DANYS KNITWEAR LTD.

Surabari, Kashimpur, Gazipur sadar, Gazipur.

27th October 2015

1st Floor. Uncontrolled storage area

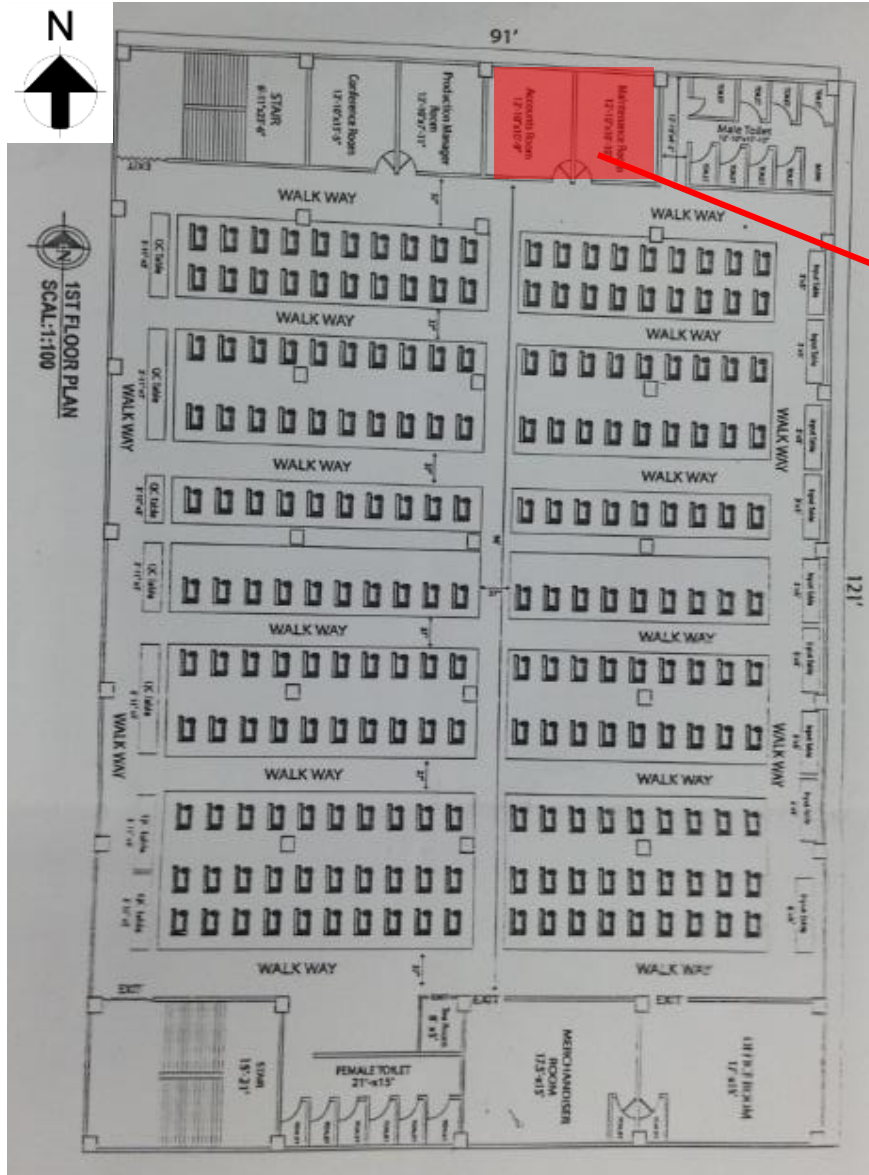
Overloaded storage areas

Item No.	Observation	Recommended Action Plan	Recommended Timeline
1	Overloaded storage areas	The quantity of the stored materials must be reduced to the level specified by the original designer	6-weeks
2	Overloaded storage areas	Building Engineer to provide a Load Plan for each level	6-weeks
3	Overloaded storage areas	Reduce loading to the recommendations of the loading plans	6-months
4	Cracks on the beams and partition walls	Remove the plaster and engage an Building Engineer to investigate the cracks on the beam	6-weeks
5	Cracks on the beams and partition walls	Repair cracks on the partition walls	6-months

2nd Floor. Horizontal crack on the beam

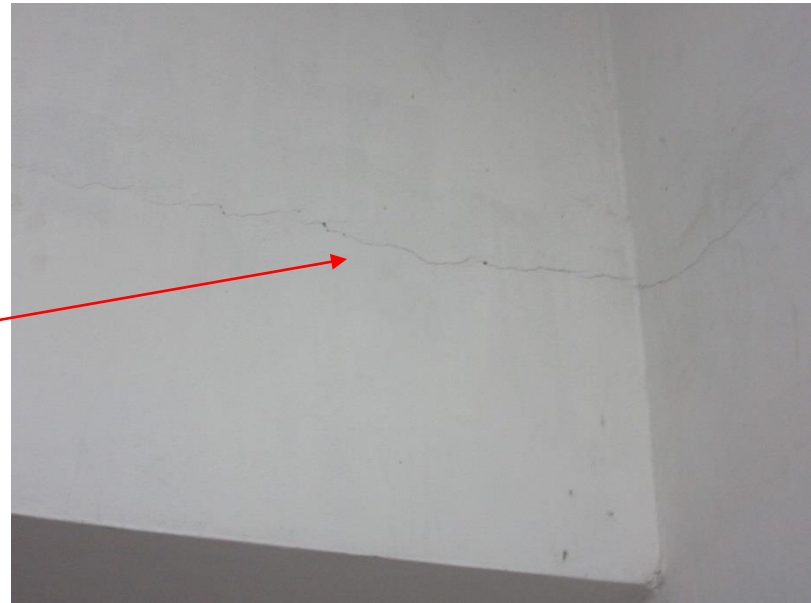
Cracks on the beams and partition walls
